ADDENDUM#	Date	No
ADDENDUM#1	12/4/09	1
Revision

MAINE MEDICAL CENTER
PAVILION 6 RENOVATIONS

SIXTH FLOOR PAVILIONS "A" & "C" MECHANICAL NEW DUCTWORK PLAN

3M2.0

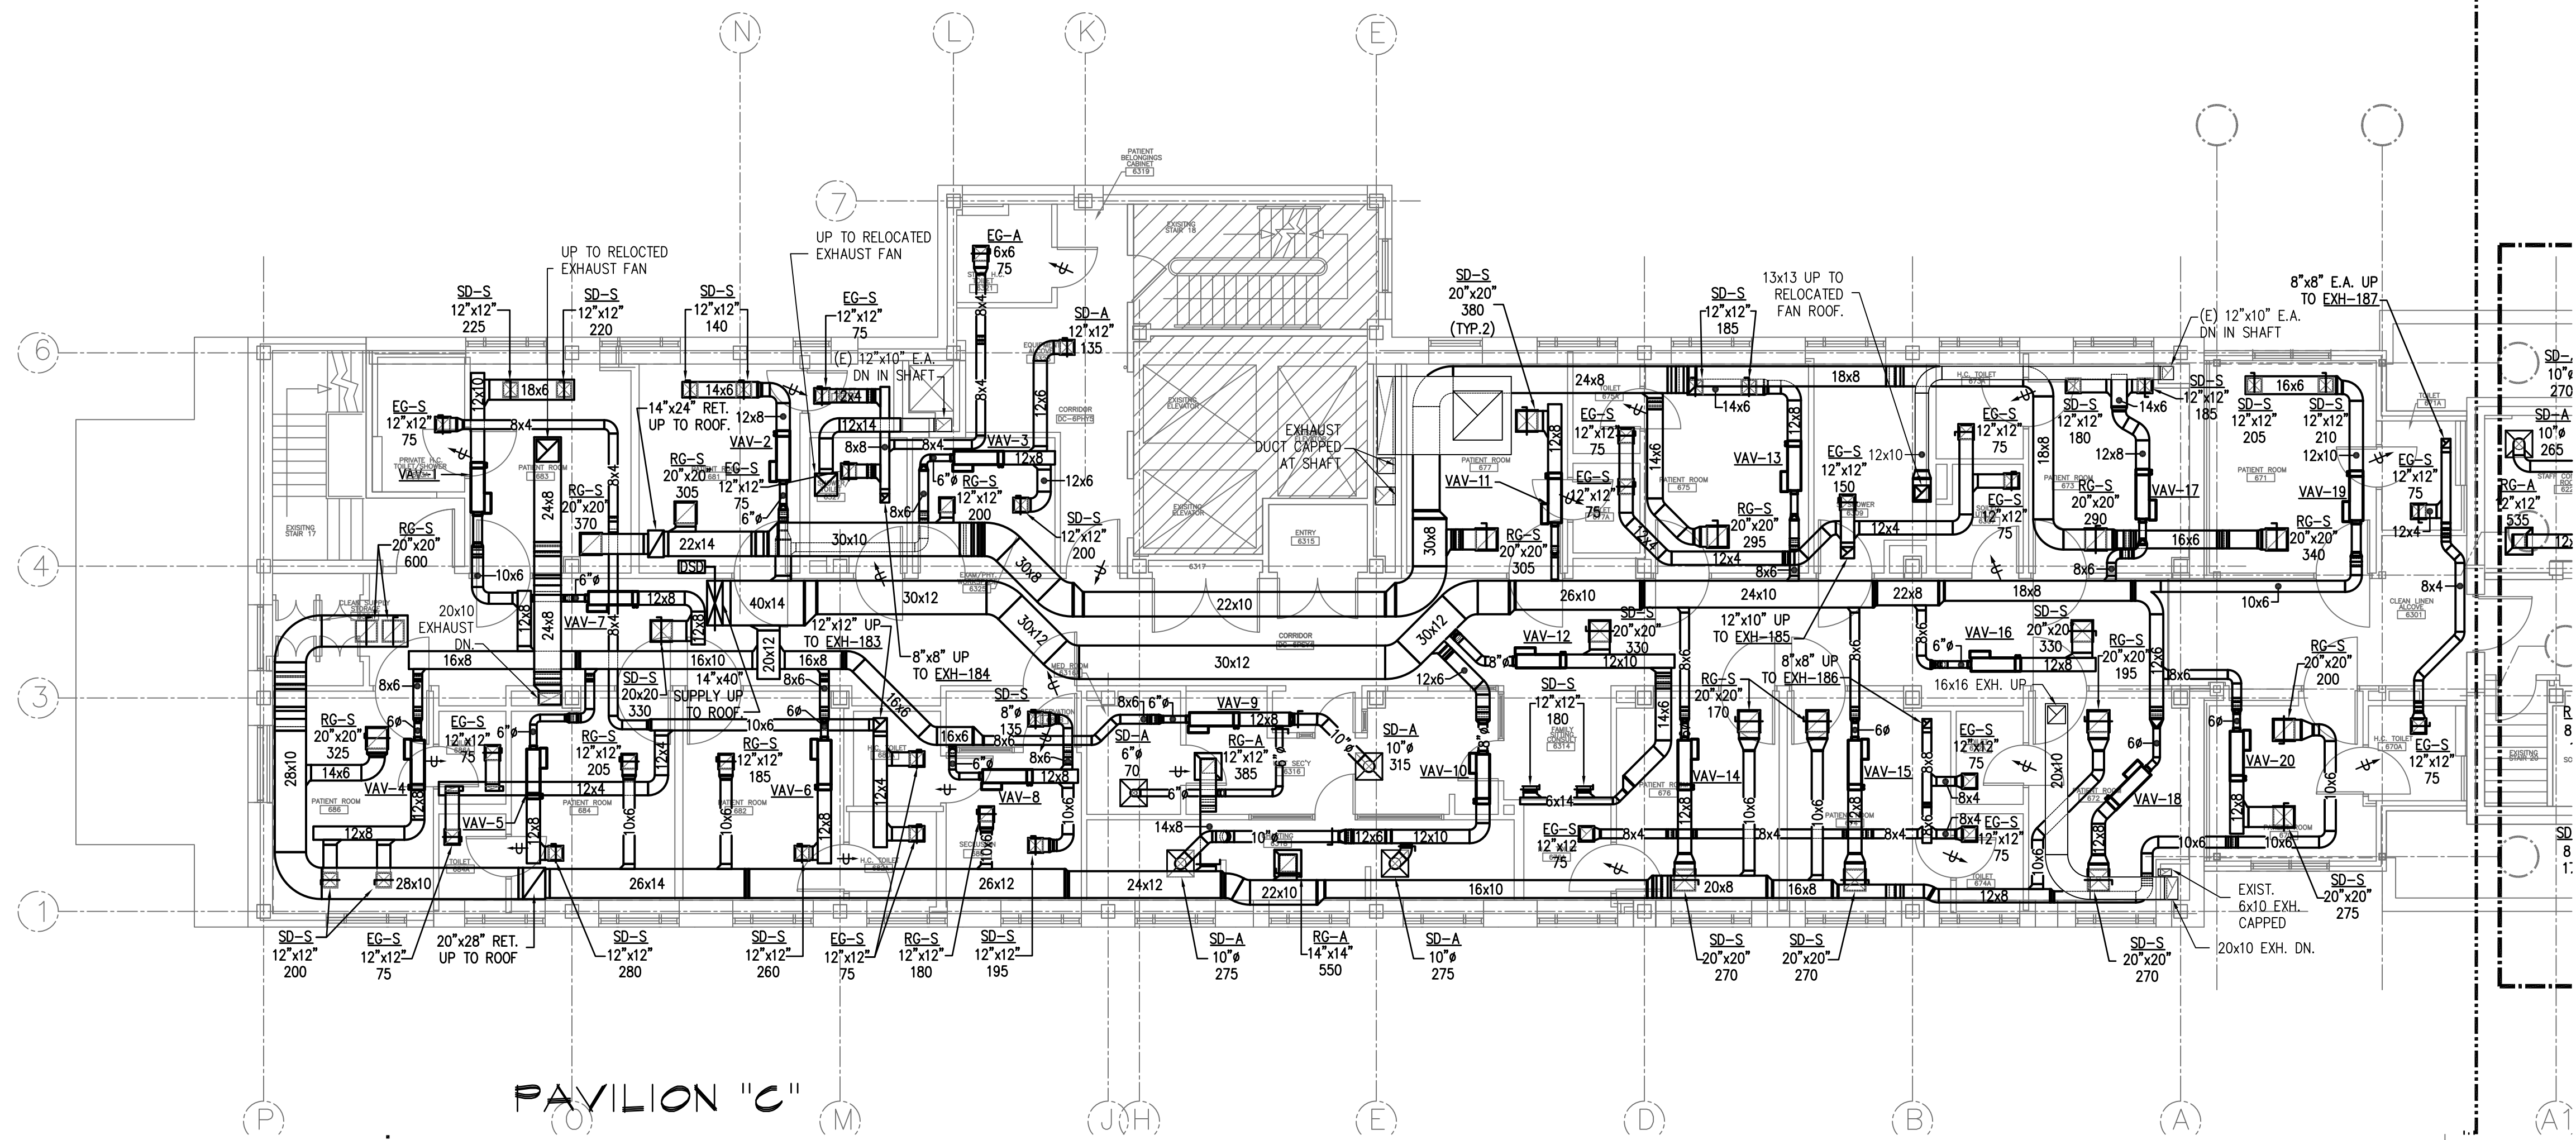
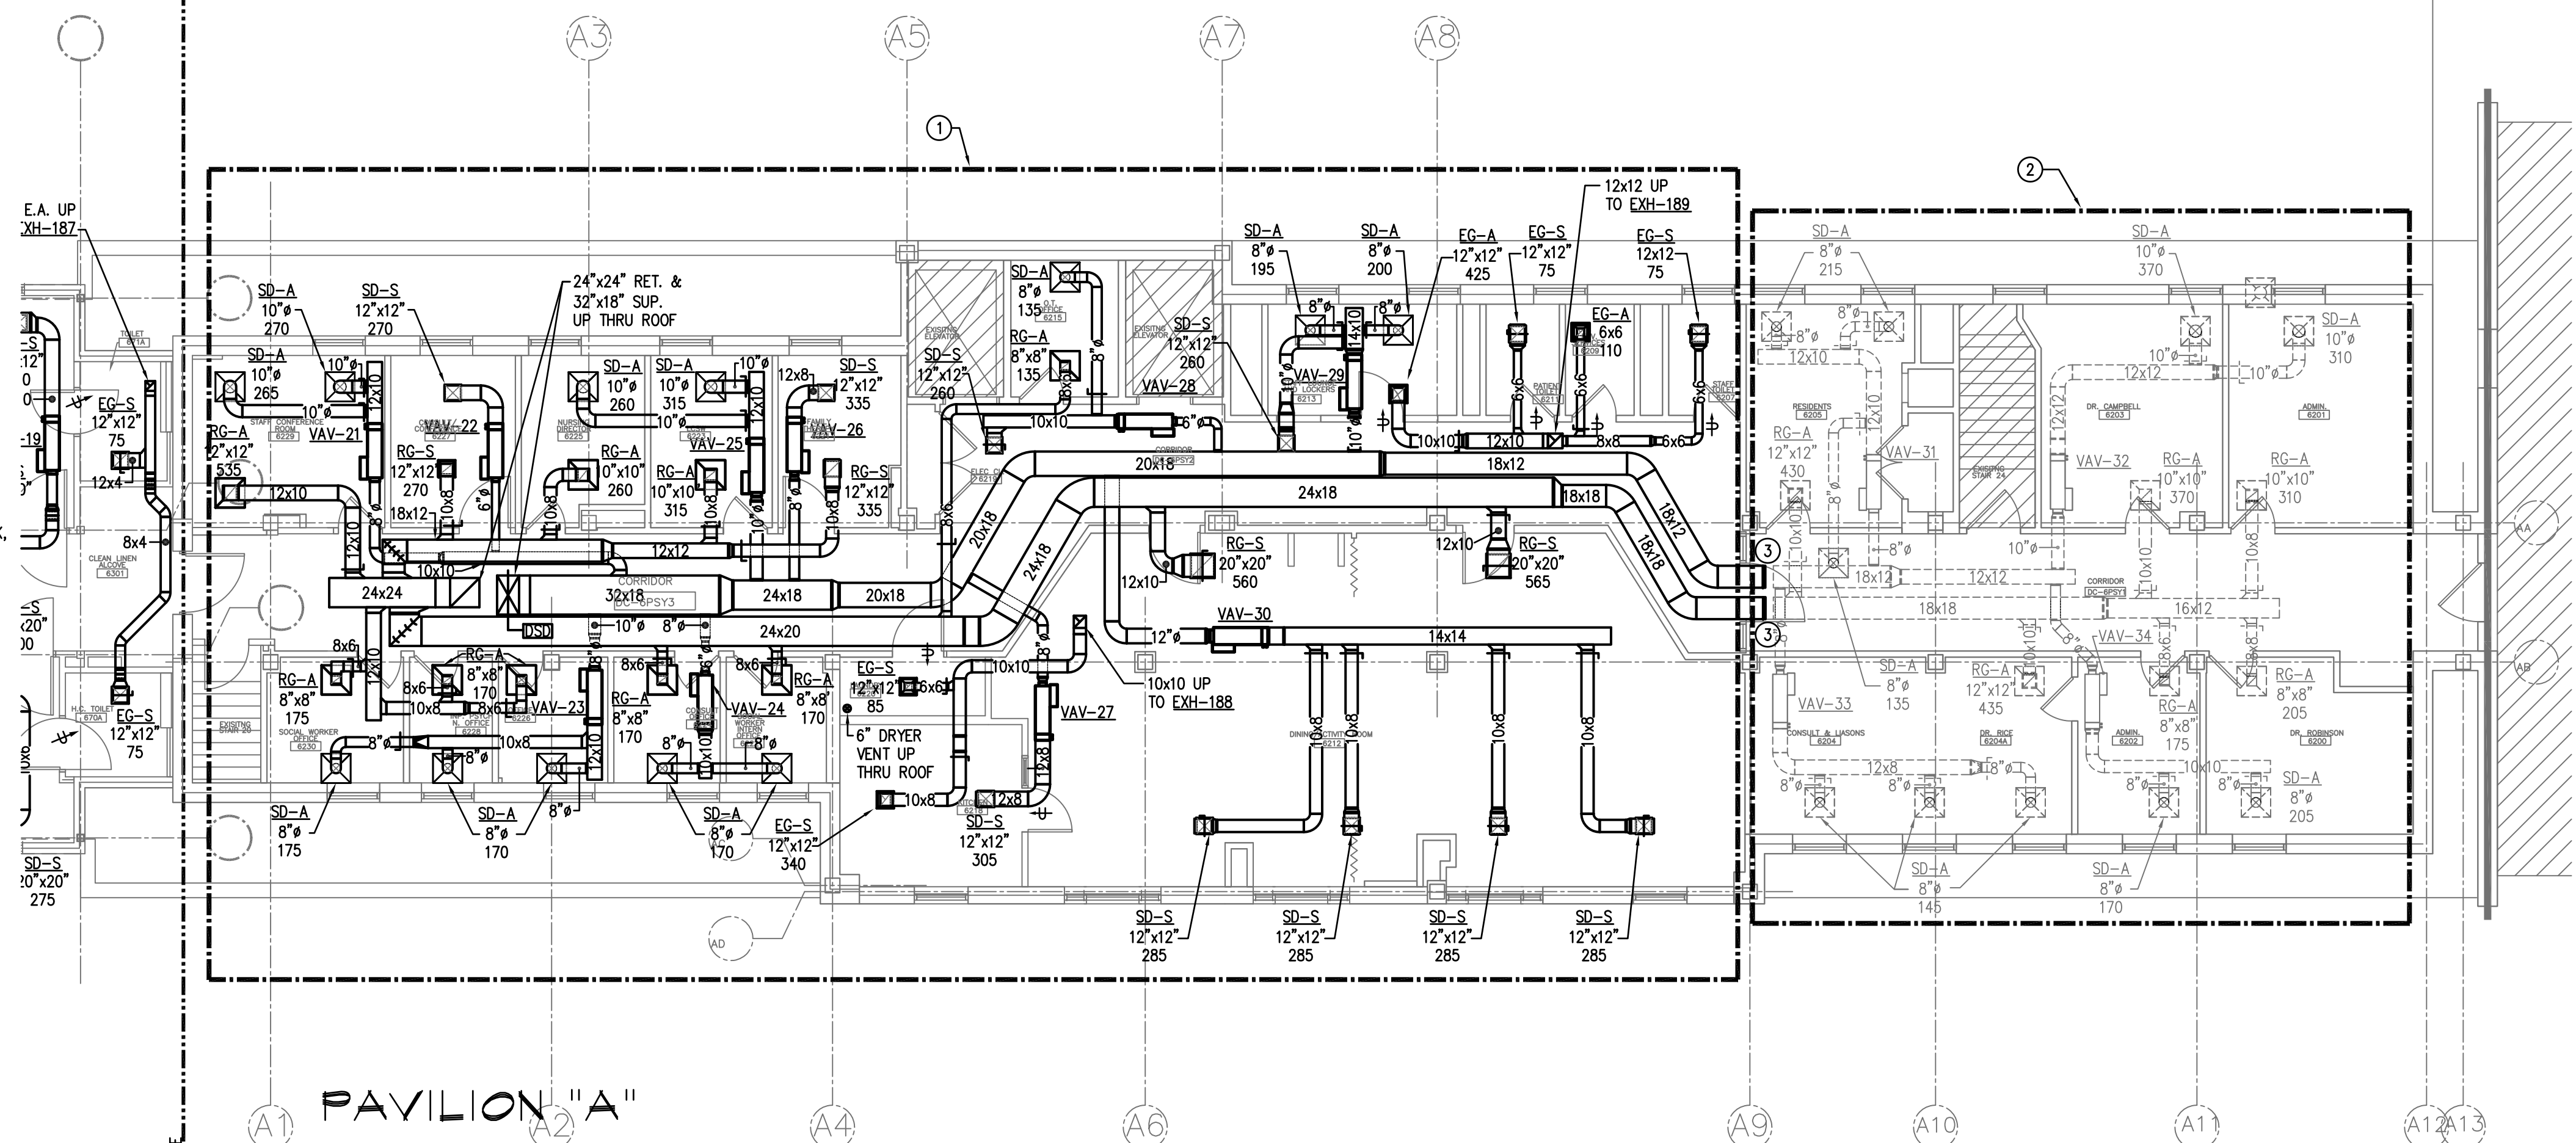
- 1 PROVIDE BID ALTERNATE (ALTERNATE #4) FOR ALL PAVILION "A" DUCTWORK, EQUIPMENT AND ACCESSORIES.
- 2 AREA OUT OF SCOPE. FUTURE WORK/EXPANSION.
- 3 CAP DUCTWORK FOR FUTURE EXPANSION.
